# Emergency Product Change Notification

## Replacement of Monolithic windows for CBT-90-UV

June 12, 2018

## Proposed: Discrete Window/Frame

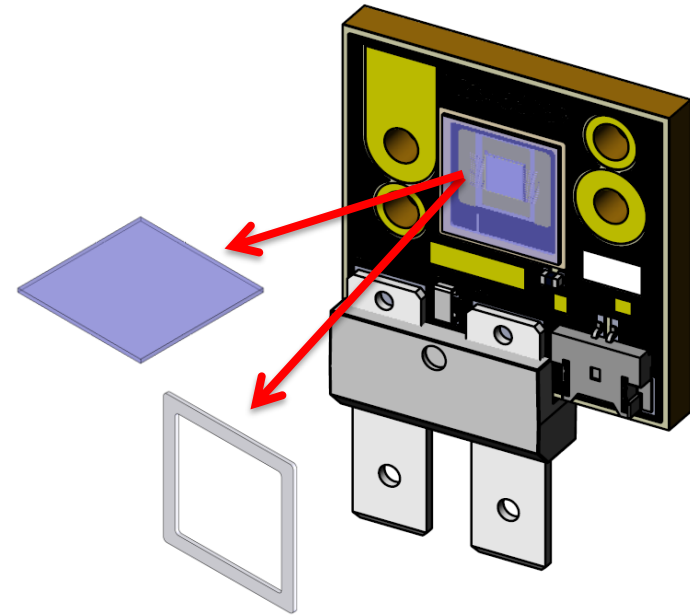
- Glass Vendor: same
- Window glass material: same
- Window glass thickness: same
- Window coating: same
- Transmission curve: same

No  
optical  
impact

Monolithic window	2-Piece Window
Glass thickness	0.30	0.30
Total thickness	0.635	0.58
Transmittance	98% min 340 - 450 nm 99% average 340 - 450 nm	95% min 400 - 420 nm 98% min 420 - 700 nm

### Monolithic Window

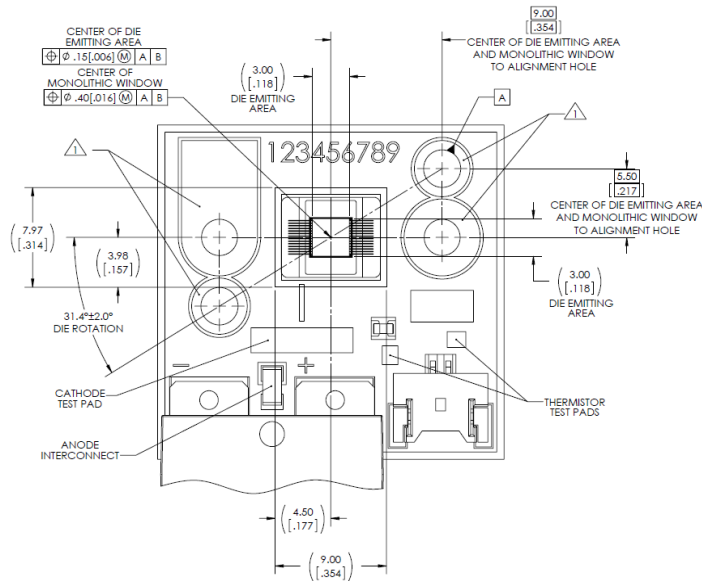
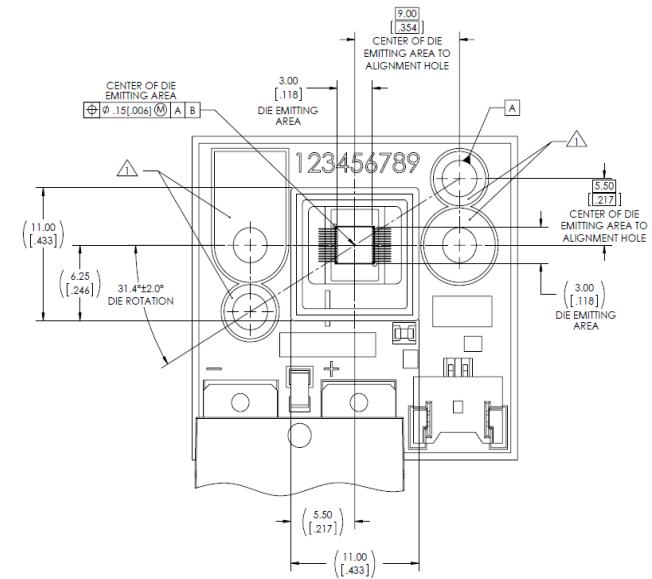
Dimension: 9.00m x 7.97mm

Dimension: 10.0m x 10.0mm

- Discrete window approach has minor differences in [XY] dimensional footprint
- Both options share same optical center placement with respect to datum
- Customers should confirm that this will not result in interference with surrounding tooling
- This is the only backwards compatibility concern with the discrete solution

## Monolithic Window

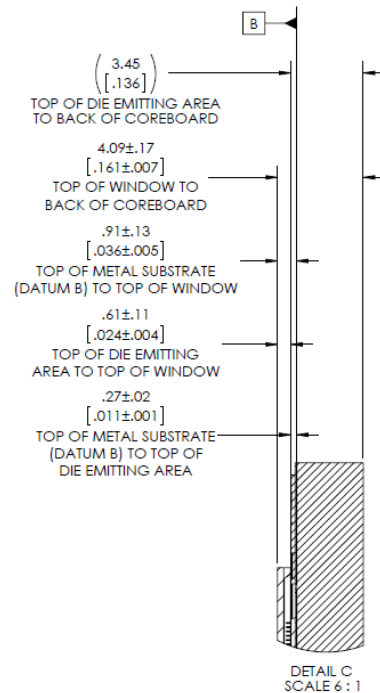
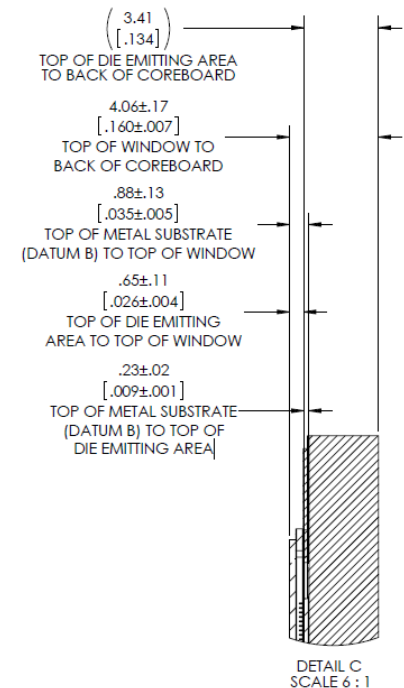
Top of die emitting area to top of window: *0.61 mm*

Top of window to back of coreboard: *4.09 mm*

Top of die emitting area to top of window: *0.65 mm*

Top of window to back of coreboard : *4.06 mm*

- Equivalent “Z-stack”: Window of Discrete option lower, ensuring no interference with surrounding tooling/optics
- As explained in slide 3, window element is identical for both approaches [thickness, material, AR coating] and made from same source glass sheets from same vendor.
